**To:** Development Permit Panel

**File:** DP 17-792077

**Re:** Application by Konic Development for a Development Permit at  
9851, 9891 Steveston Highway and 10931 Southgate Road

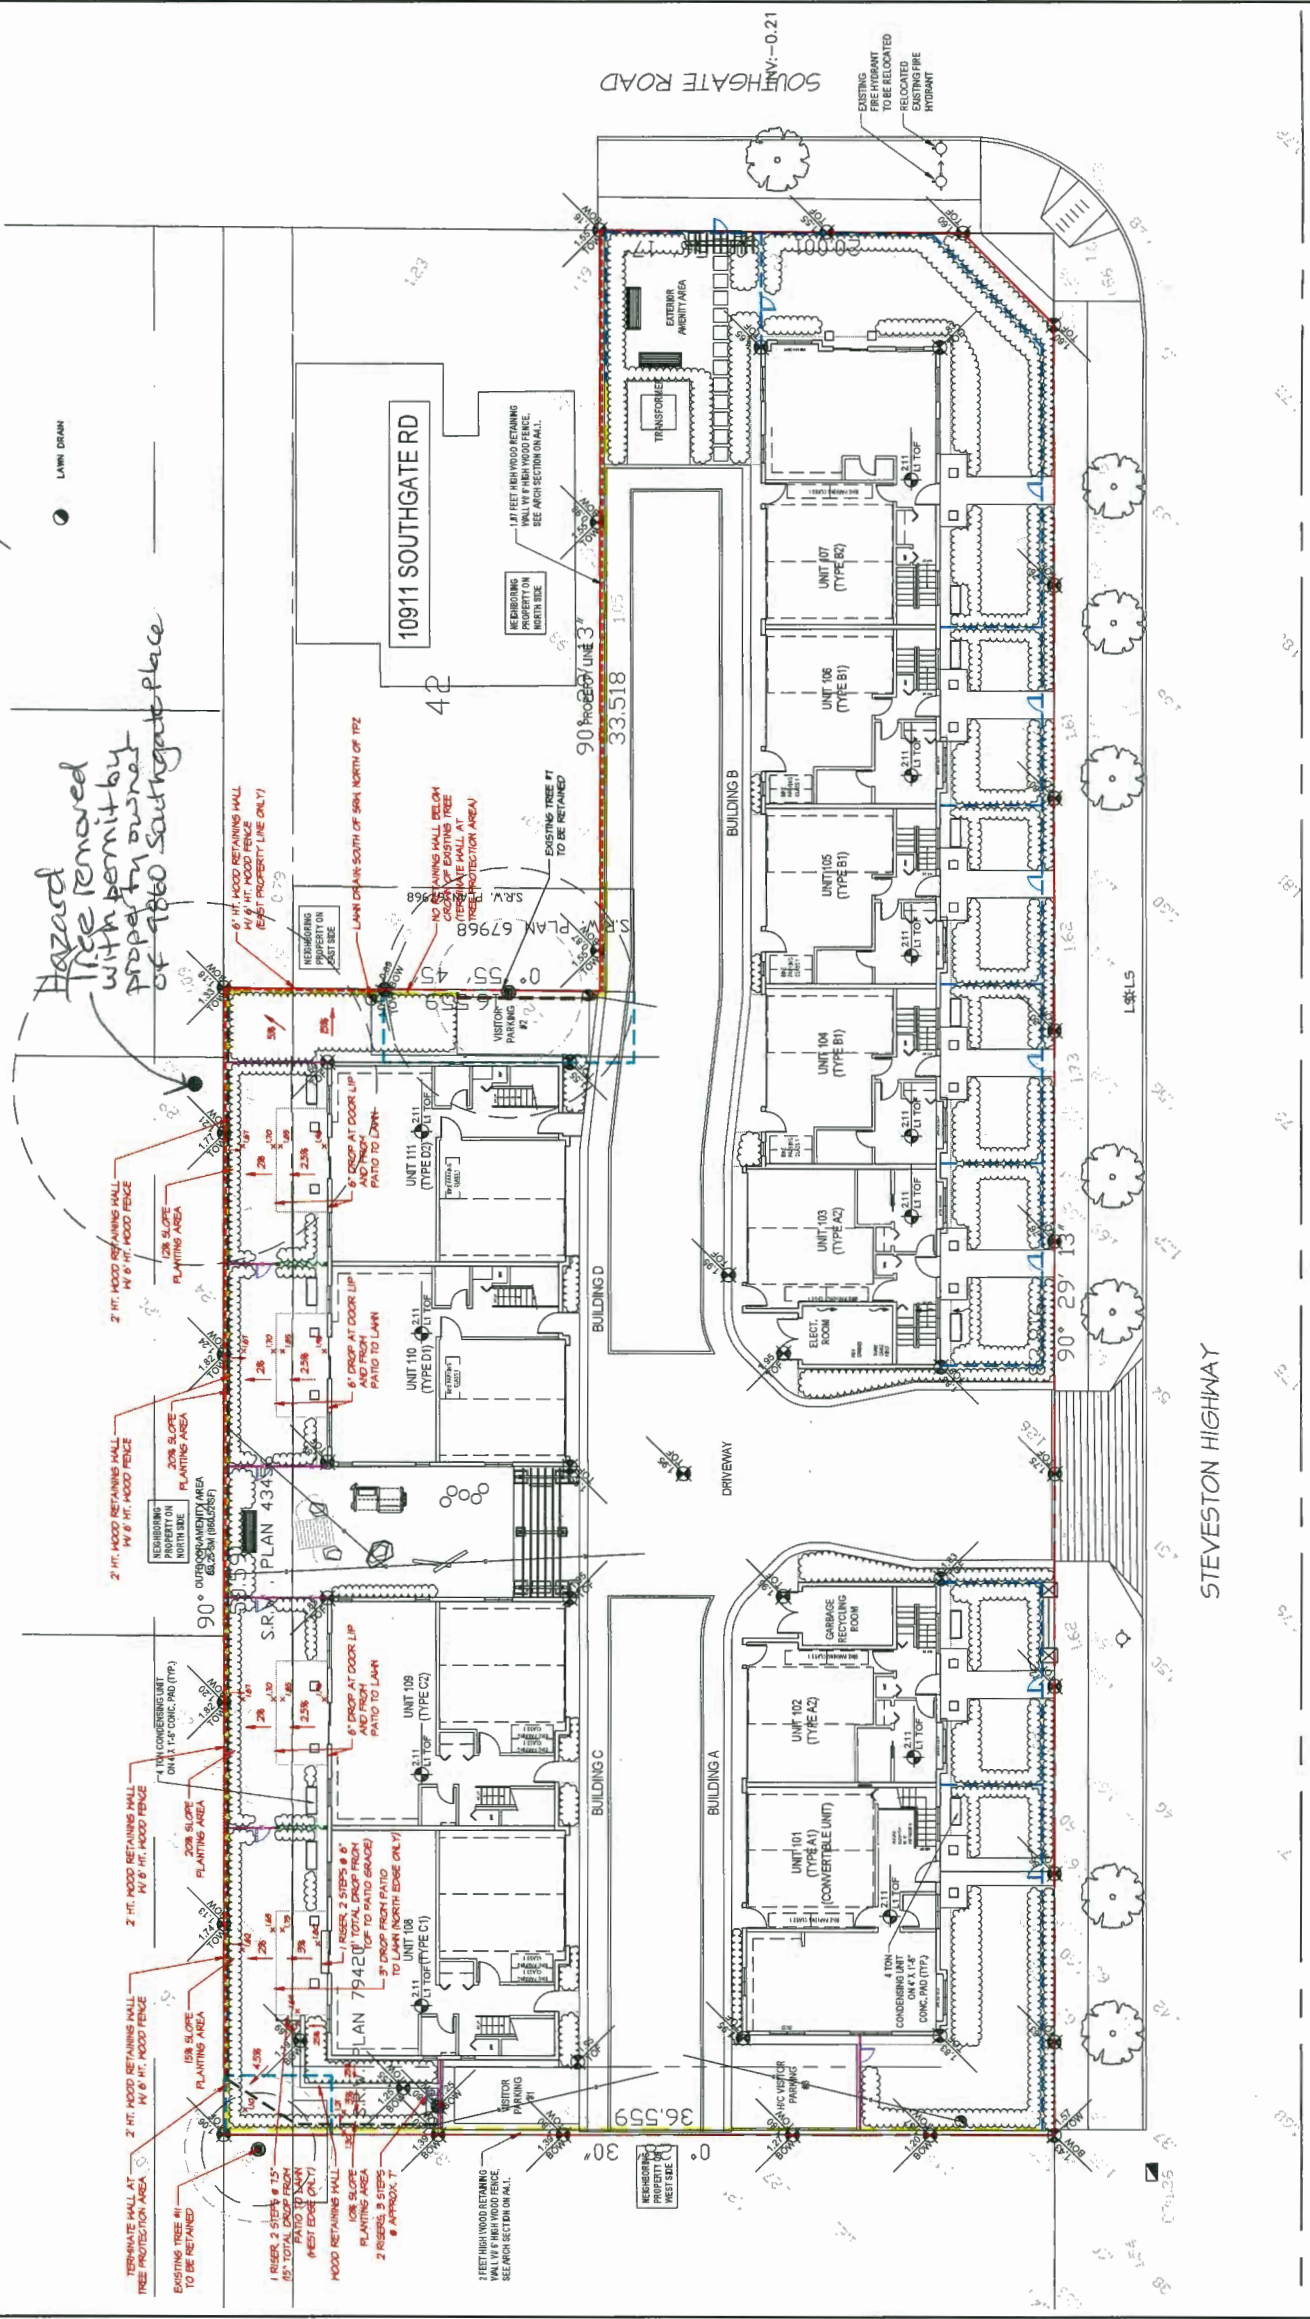
- support the pedestrian walkway articulation on the internal drive aisle; consider adding a matching permeable pathway along the south side of the internal drive aisle for pedestrian circulation to Buildings A and B; also consider adding pedestrian connections with a different paving pattern or colour treatment from the main sidewalk to the interior pedestrian networks; ***Decorative paving at site entry extended to east-west pedestrian pathway on internal drive aisle to provide connection to outdoor amenity area. Additional matching permeable pathway along the south side of the internal drive-aisle is proposed. Paving pattern/colour treatment for interior network is different than main sidewalk as requested.***

- appreciate the applicant's presentation of the project; commend the applicant for providing a plant list with larger fonts; ***Noted.***
- concerned that the pedestrian treatment on the internal drive aisle may be underused by pedestrians and has potential maintenance issues; ***Decorative paving at site entry extended to 3' wide east-west pedestrian pathways on both the north and south sides of the internal drive aisle to provide connection to outdoor amenity area; this will encourage pedestrian usage throughout the site and promote entry to the outdoor amenity space. Maintenance should not be a concern as decorative paving within drive-aisles is common.***

- consider extending the permeable paving treatment on the site entry up to the intersection and connect to the outdoor amenity space to enhance on-site pedestrian experience; *East-west pathway along north side of internal drive-aisle has been maintained, and additional matching permeable pathway along the south side has been proposed. Decorative paving at site entry extended to east-west pedestrian pathway on internal drive aisle to provide connection to outdoor amenity area; this will encourage pedestrian usage and promote entry to the outdoor amenity space.*

- proposed treatment of the north side of the internal drive aisle with permeable pavers to define on-site pedestrian circulation could either be maintained or eliminated due to potential maintenance issues; ***East west pathway along north side of internal drive aisle has been maintained, additional matching permeable pathway along the south side is proposed. Decorative paving at site entry extended to these pathways to provide connection to outdoor amenity area; this will encourage pedestrian usage and promote entry to the outdoor amenity space.***

- and, support the proposal from the Panel to extend the permeable paving treatment at the site entry through the intersection up to the outdoor amenity area to bring the amenity area out into the street to highlight the area and allow more play opportunities for children. *Decorative paving at site entry extended through the intersection up to the outdoor amenity area, and connected to the 3' wide east-west pedestrian pathways on both the north and south sides of internal drive-aisle to provide connection to outdoor amenity area; this will encourage pedestrian usage throughout the site and promote entry to the outdoor amenity area while bringing the amenity area out towards the street to highlight the area and allow additional play opportunities.*

**6 6' HT. WOOD TRELLIS**  
 SCALE: 1/2" = 1'-0"  
 3g

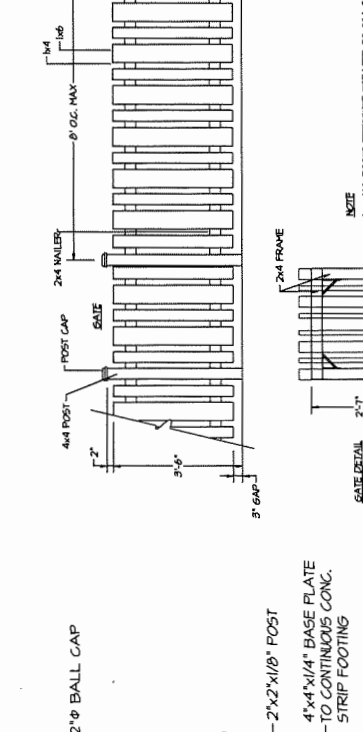
- consider rearranging the play elements in the outdoor amenity area to under accentuate the linearity of the space; also, the bench is not located in the best location; *Trellis at amenity area entry provides greater sense of arrival. Trellis has been made wider so that the mail kiosk, pathway, and bike rack are all underneath the trellis. The wider structure will also allow for more circulation through the area. Play elements have been rearranged and spaced out to provide more room down the middle of the area. The elements are arranged to promote continuity and a theme/linearity from one feature to another. Allows for children to work their way through the space from south to north. Bench within central amenity area has been relocated. It is not intended to be set in cast-in-place concrete, rather installed within the planting bed; this is not an uncommon practice.*

- also agree with Panel comment to eliminate the trellis as it would hide the amenity space and make it feel more constrained; *Trellis at amenity area entry provides greater sense of arrival. Trellis has been made wider so that the mail kiosk, pathway, and bike rack are all underneath the trellis. The wider structure will also allow for more circulation through the area.*

EXISTING TREE #1 AREA ALONG EAST PROPERTY LINE  
 (FACING WEST)

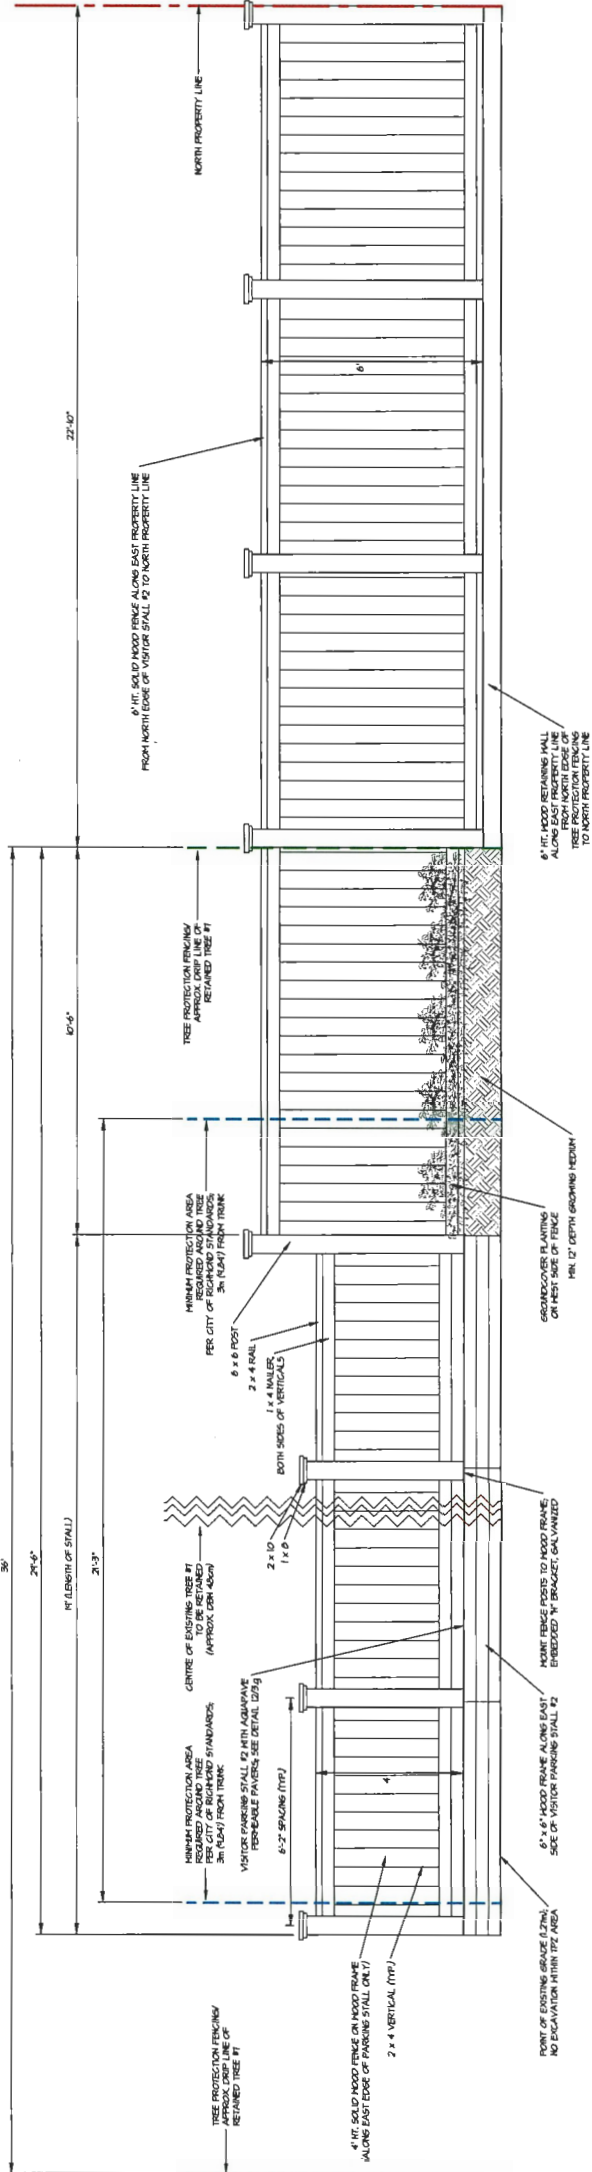
- appreciate the applicant's efforts to retain the existing tree adjacent to Unit 111; however, the applicant is cautioned on the survivability of the retained tree considering its proximity to the townhouse unit; *Details of construction around existing tree illustrated on tree management plan and landscape detail/section.*
